PROJECT
Natural History Museum UNLOCKED
THAMES VALLEY SCIENCE PARK

TITLE
SITE WIDE PUBLIC REALM
DRAINAGE AND LEVELS
PLAN 1/2

Scale:	Date:	Drawn:	Checked:	Approved:
1:250@ A1	02/05/2025	MS	KF	KF
Status:	STAGE 4			
Drawing Number:	RD001-FCB-XX-XX-DR-L-2101			
Rev:	P05

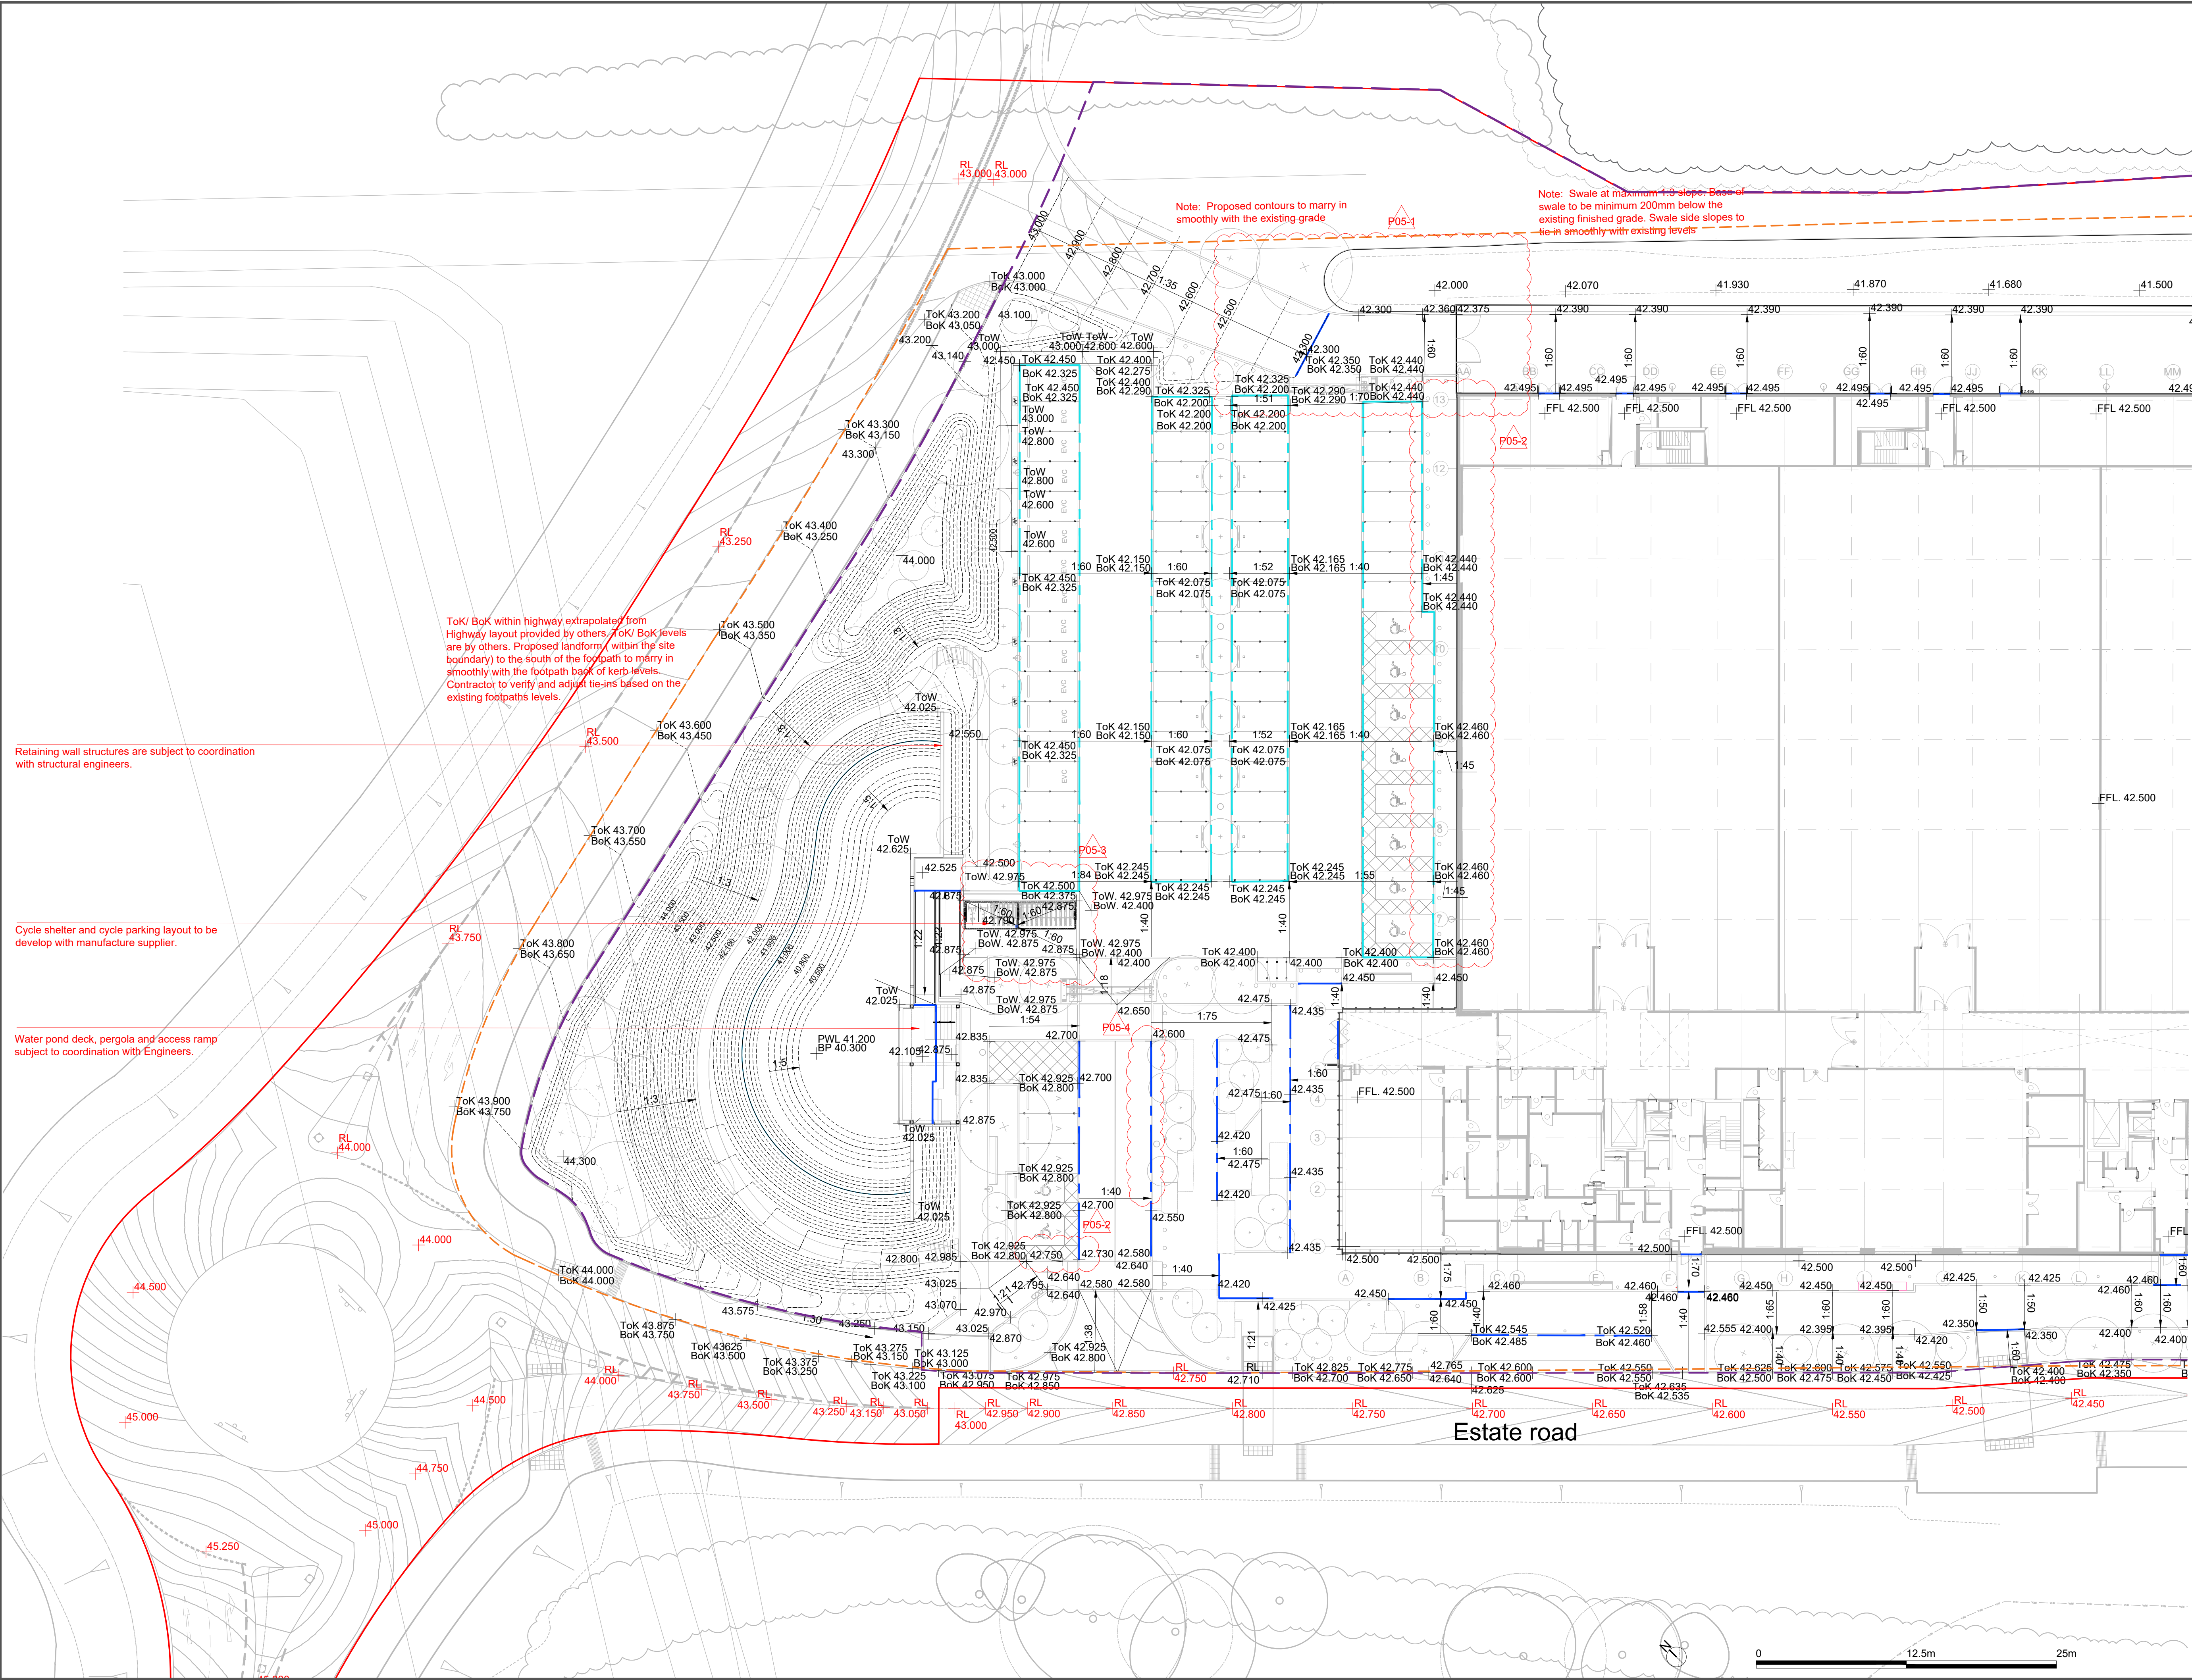
- East road level and drainage updated. Swale extension updated to optimize SUD strategy.
- Level change to accommodate flush kerb along accessible car parks.
- Levels and drainage updated in the bike shelter area.
- Levels and drainage updated along planter.
